PVNGS UNIT 1

**MARKED UP TECHNICAL SPECIFICATIONS
TO SUPPORT NRC GENERIC LETTER 88-16**

FIGURE 3.2-2

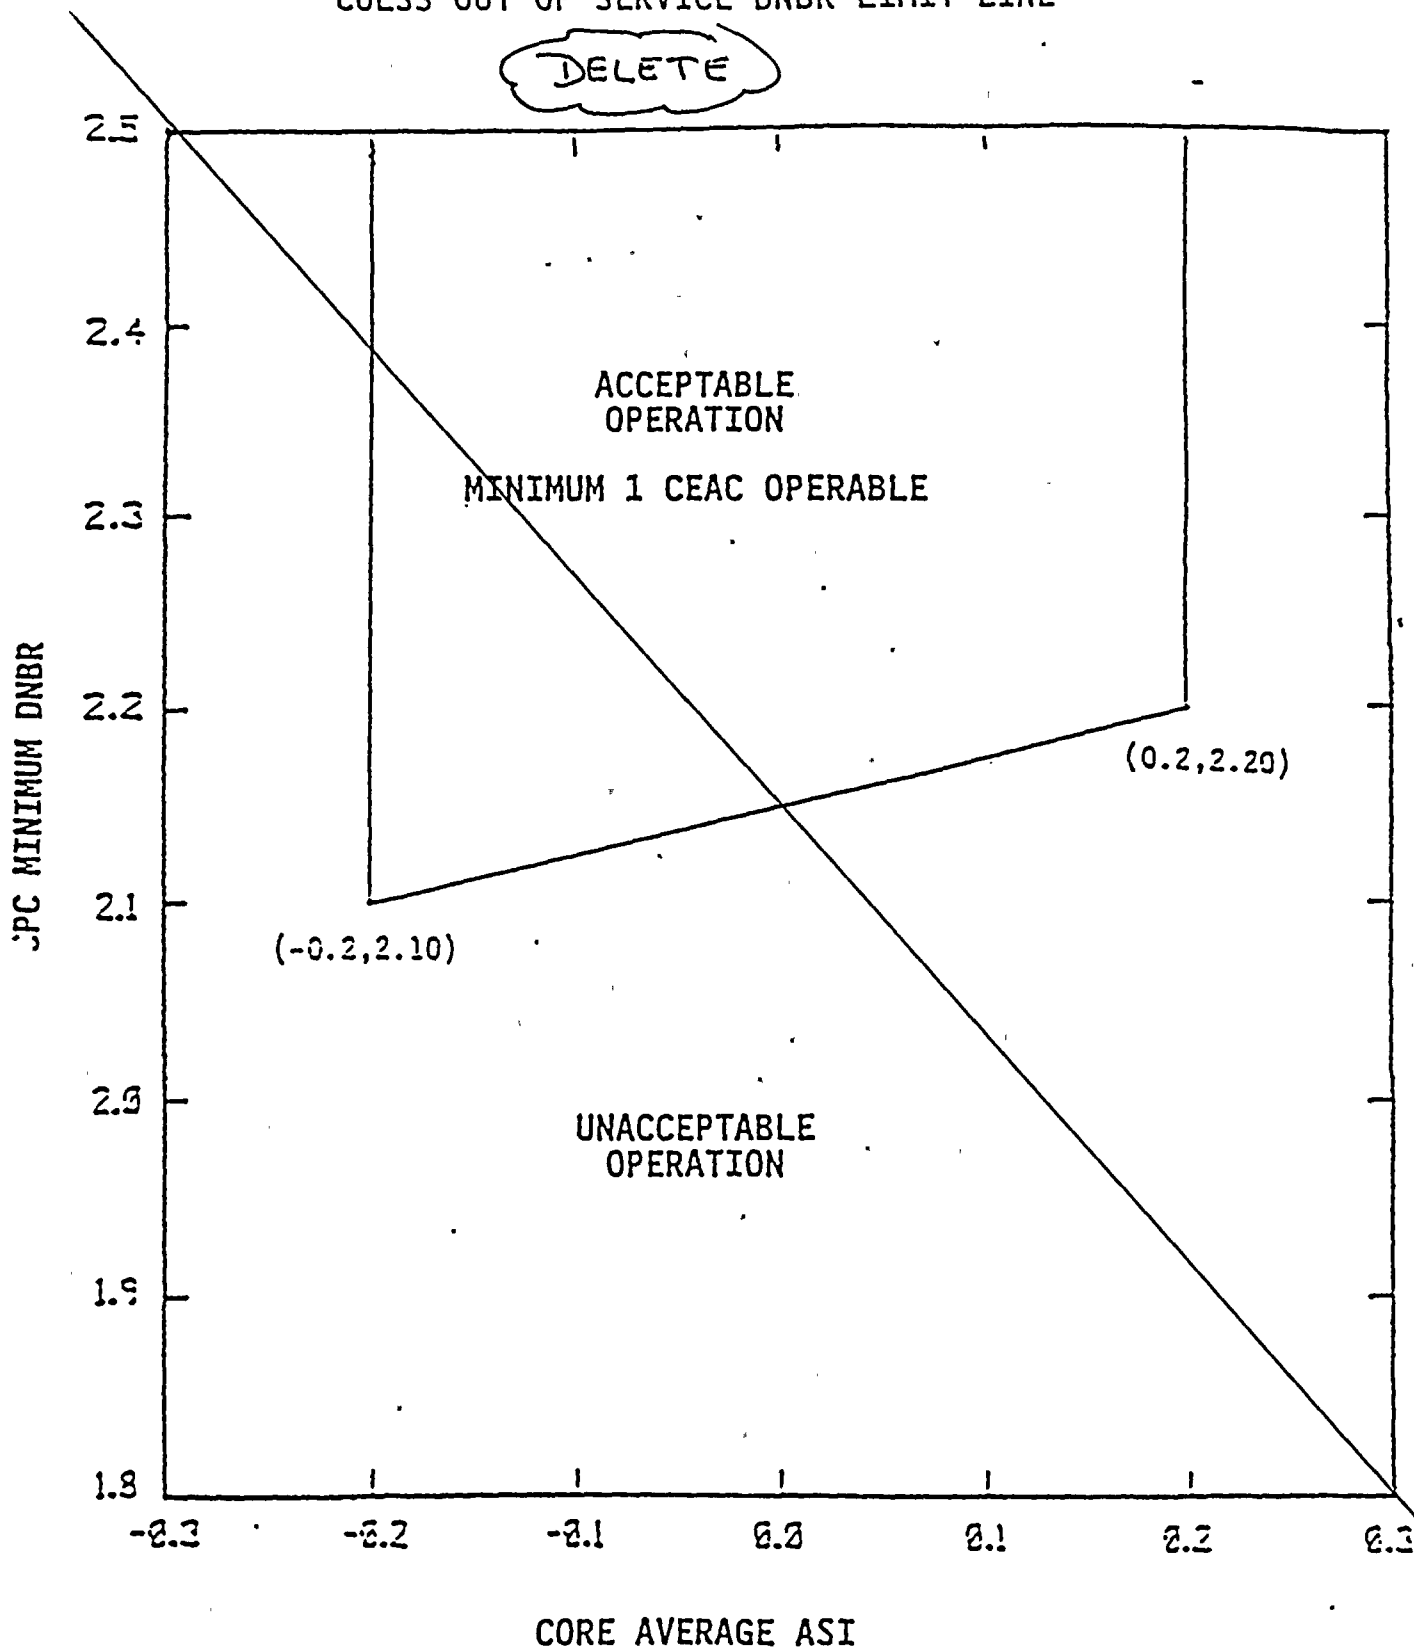
DELETE

FIGURE 3.2-2a

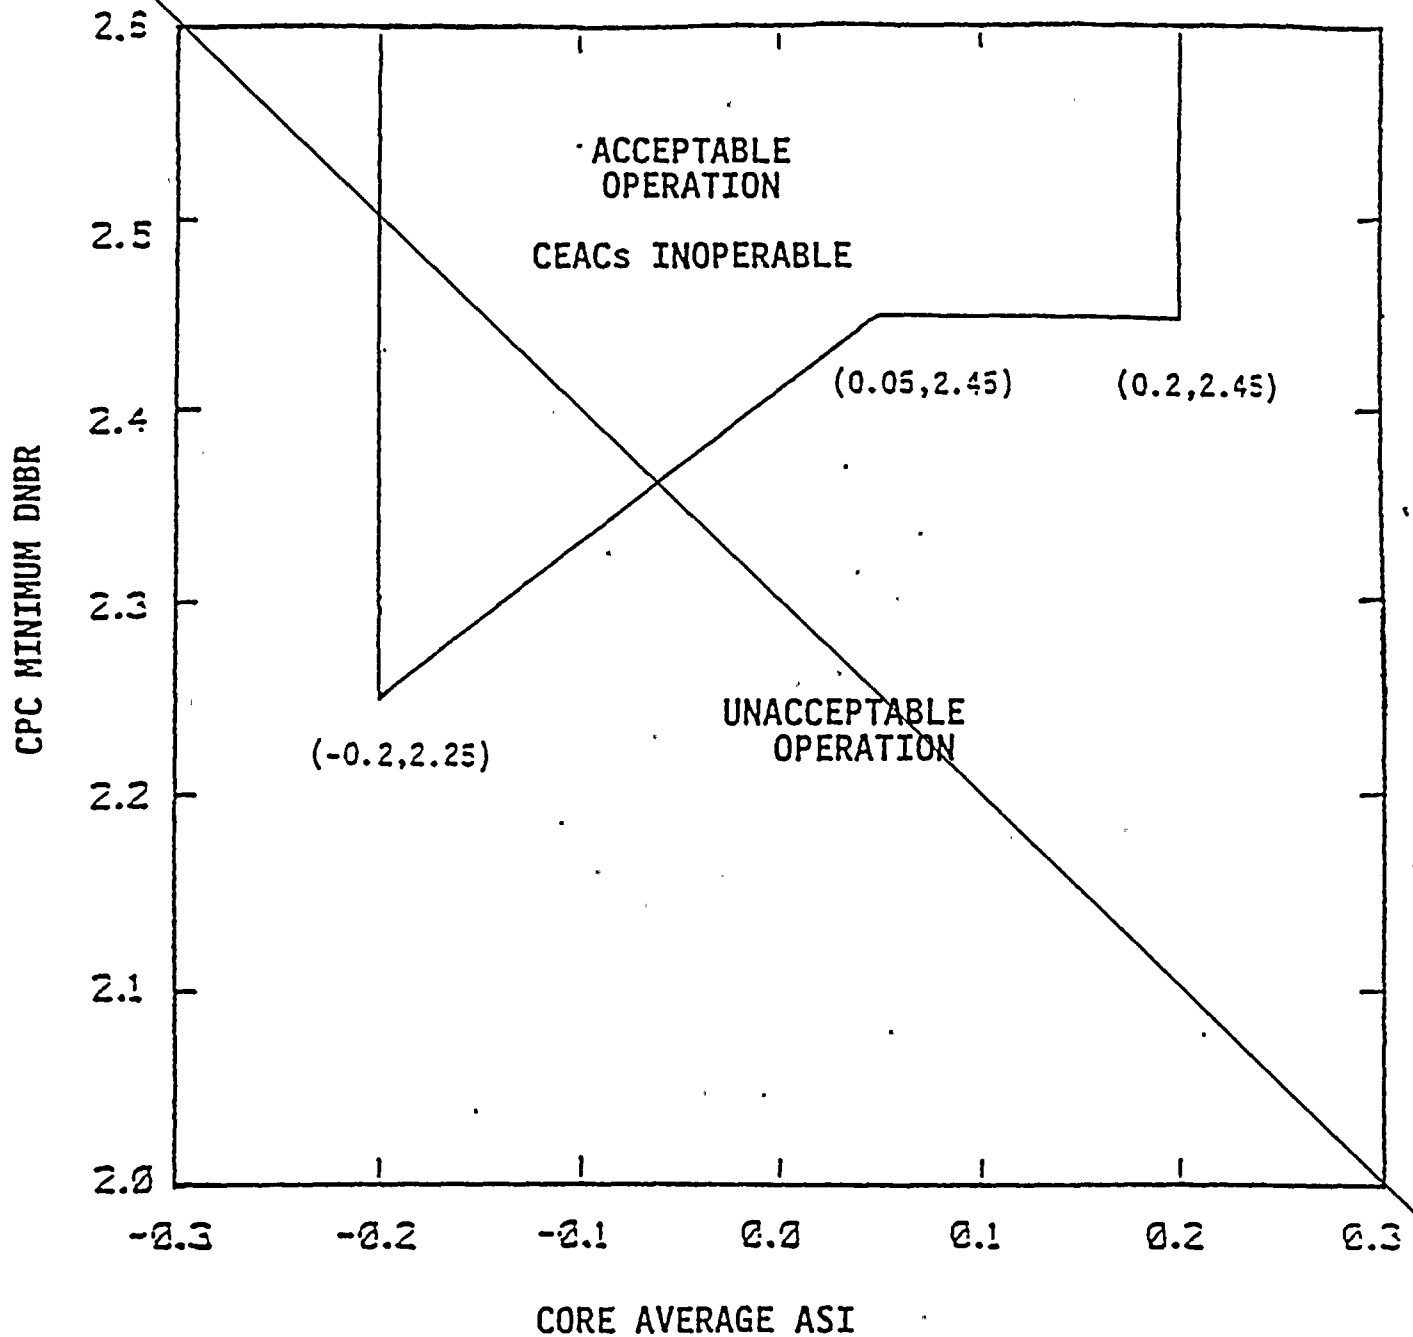
DELETE

FIGURE 3.1-1A

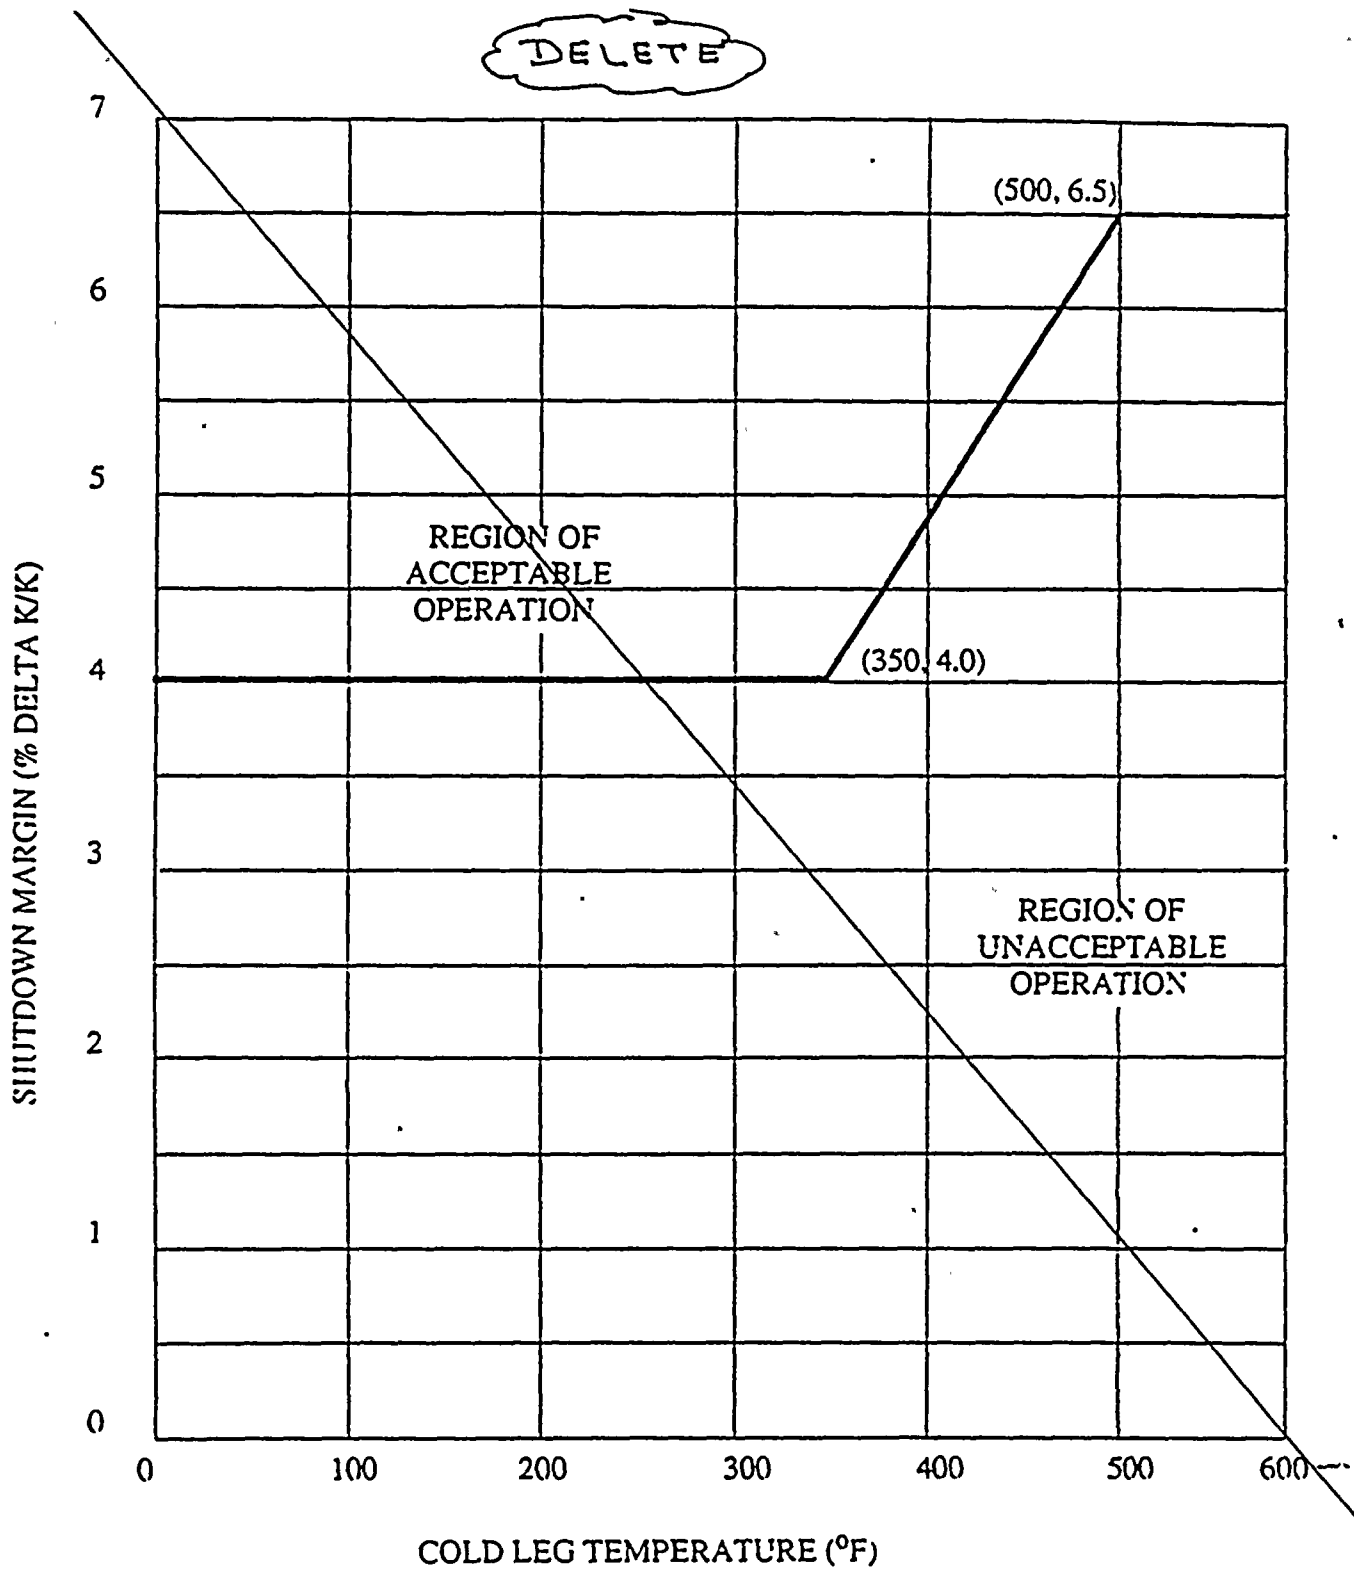
- a. The SHUTDOWN MARGIN shall be greater than or equal to that ~~shown in Figure 3.1-1A,~~ and
- b. For T_{cold} less than or equal to 500°F, K_{N-1} shall be less than 0.99.

- a. With the SHUTDOWN MARGIN less than that ~~in Figure 3.1-1A,~~ immediately initiate and continue boration at greater than or equal to 26 gpm to the reactor coolant system of a solution containing greater than or equal to 4000 ppm boron or equivalent until the required SHUTDOWN MARGIN is restored, and
- b. With T_{cold} less than or equal to 500°F and K_{N-1} greater than or equal to 0.99, immediately vary CEA positions and/or initiate and continue boration at greater than or equal to 26 gpm to the reactor coolant system of a solution containing greater than or equal to 4000 ppm boron or equivalent until the required K_{N-1} is restored.

DELETE

FIGURE 3.1-1

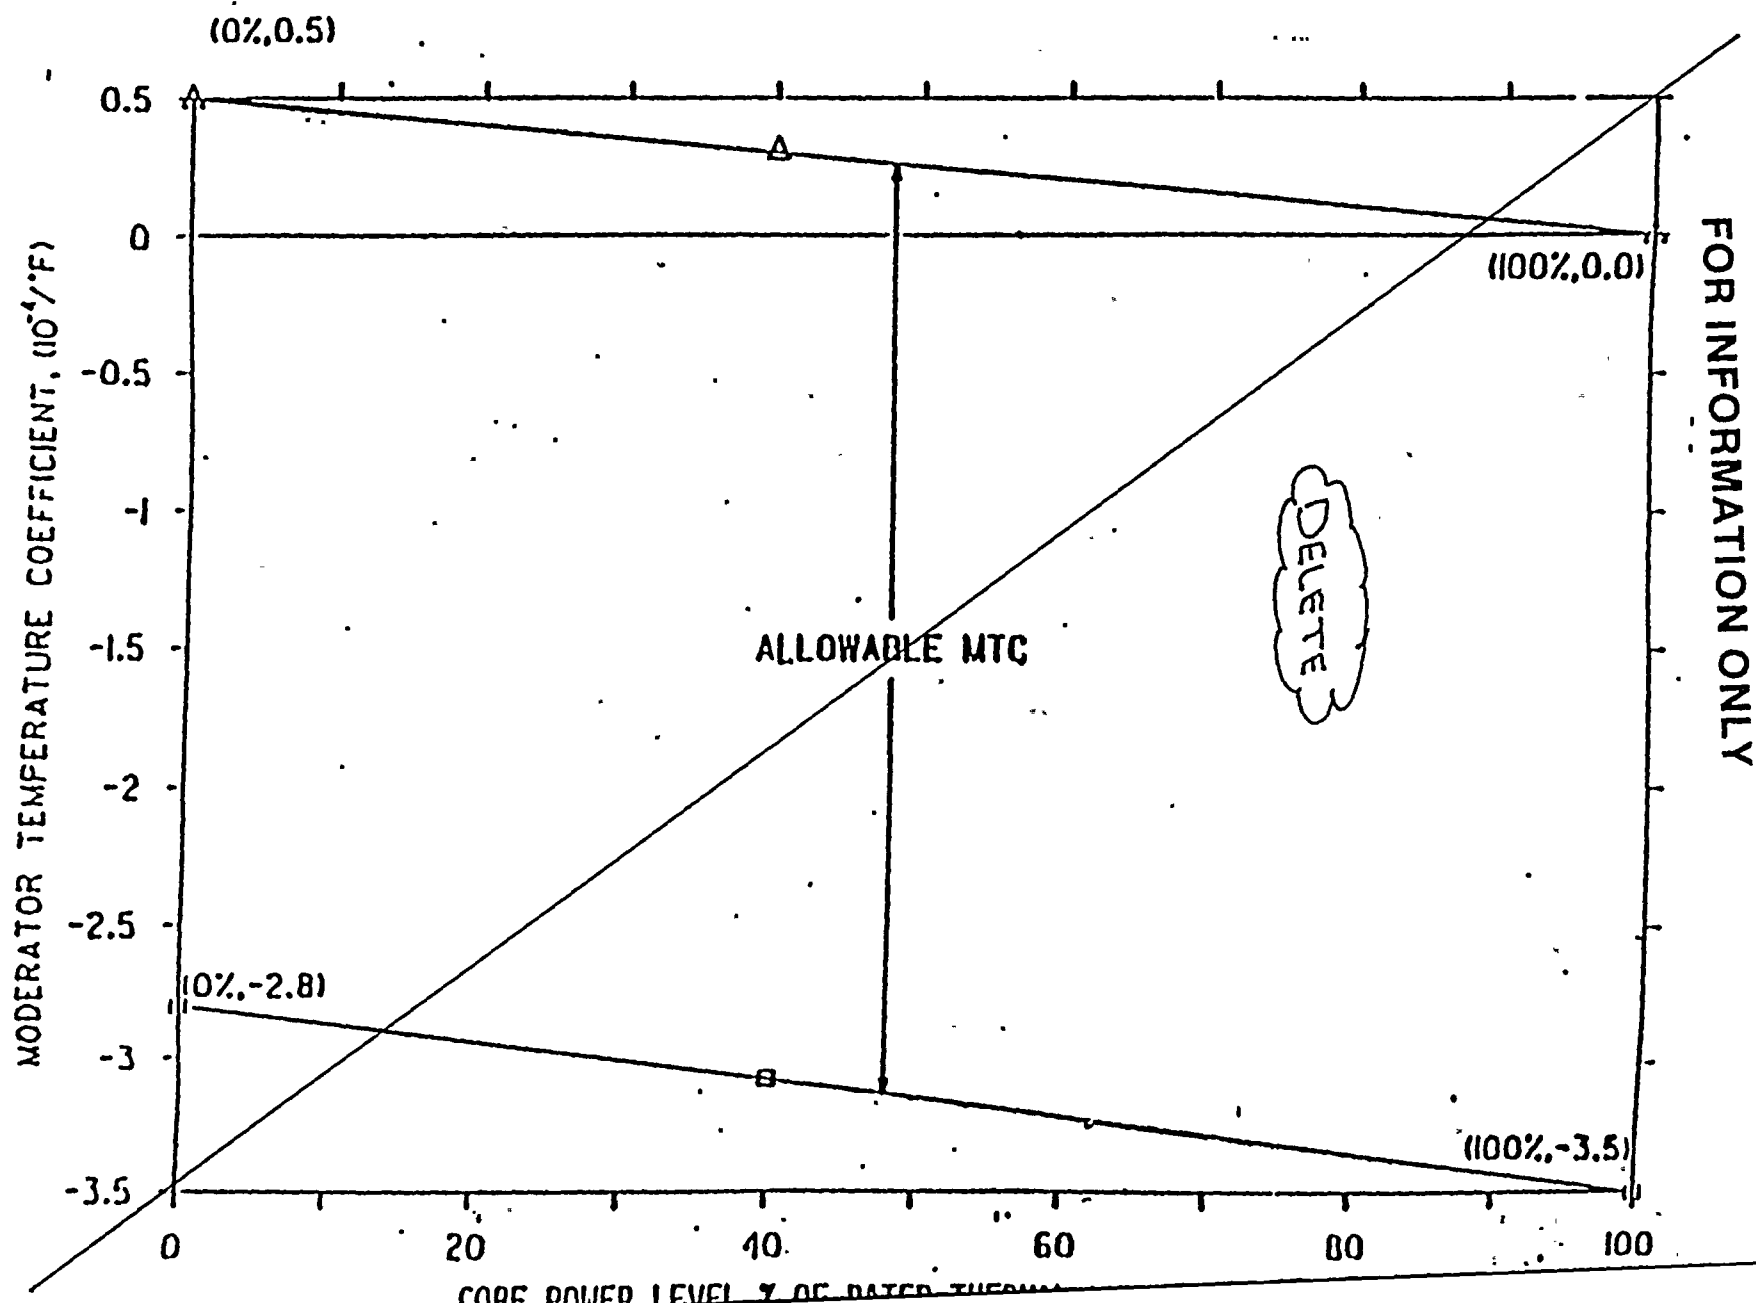
3.1.1.3 The moderator temperature coefficient (MTC) shall be within the area of Acceptable Operation, ~~shown on Figure 3.1-1.~~

With the moderator temperature coefficient outside the area of Acceptable Operation, ~~shown on Figure 3.1-1,~~ be in at least HOT STANDBY within 6 hours.

FIGURE 3.2-1A
AZIMUTHAL POWER TILT LIMIT
VS
THERMAL POWER
(COLSS IN SERVICE)

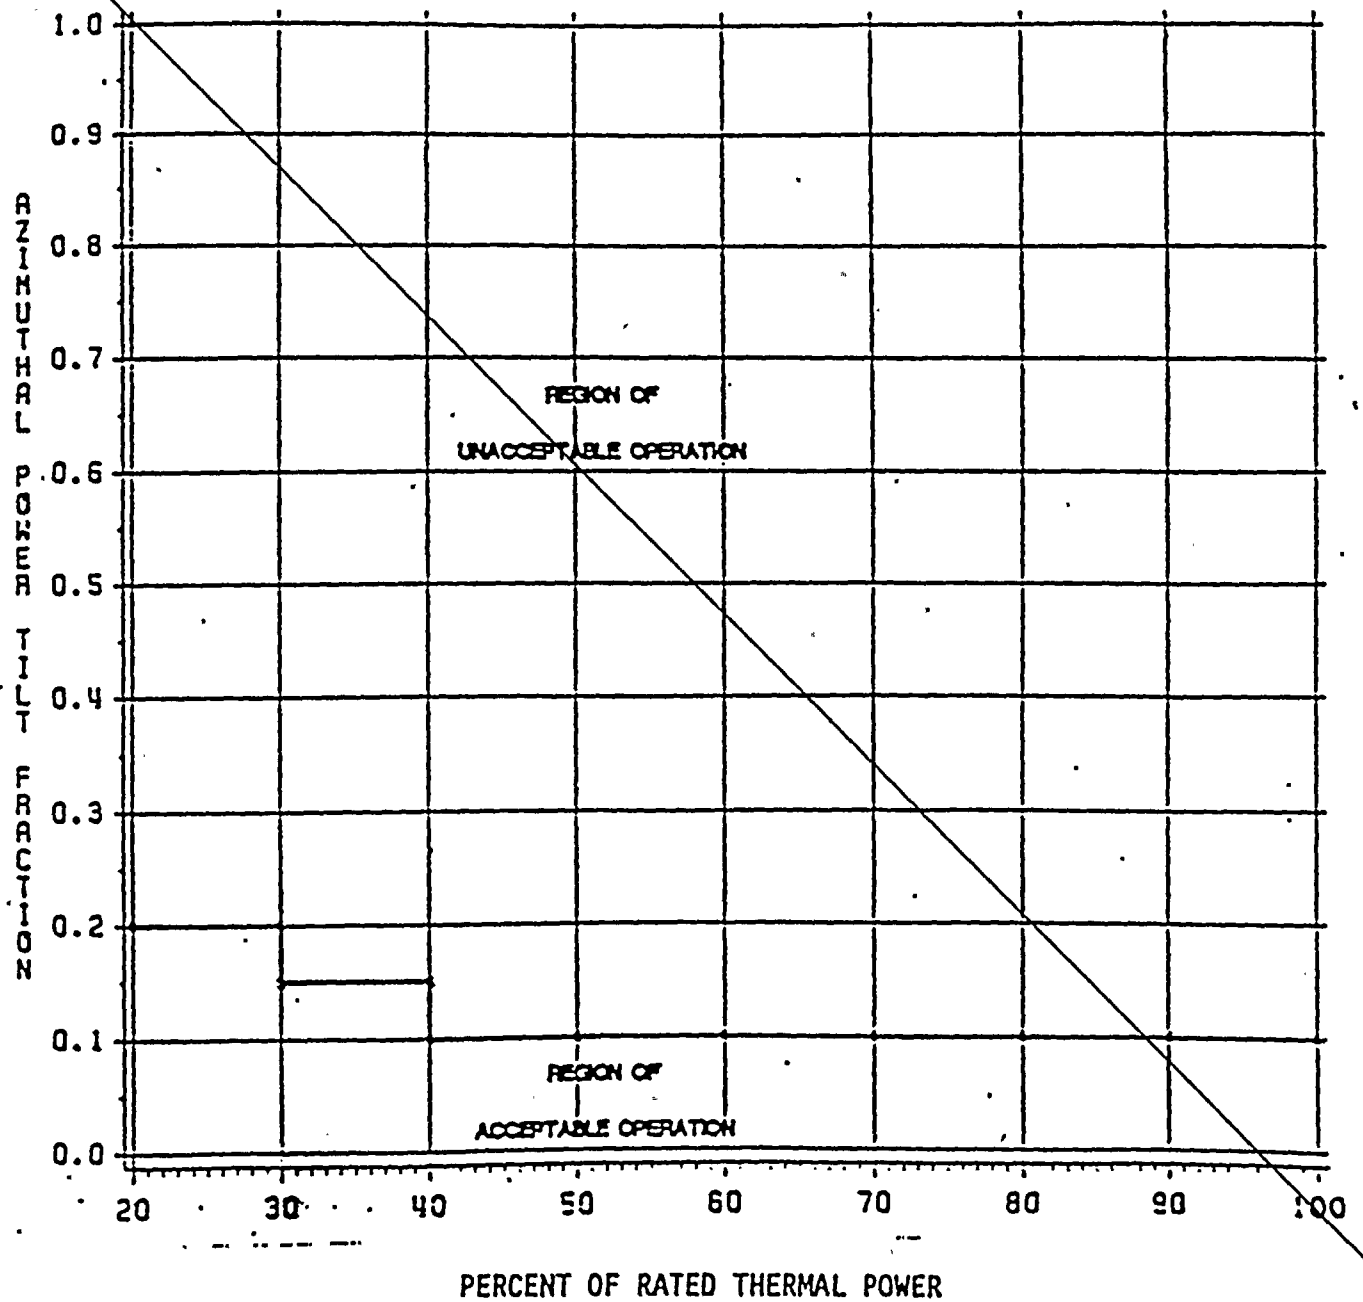
DELETE
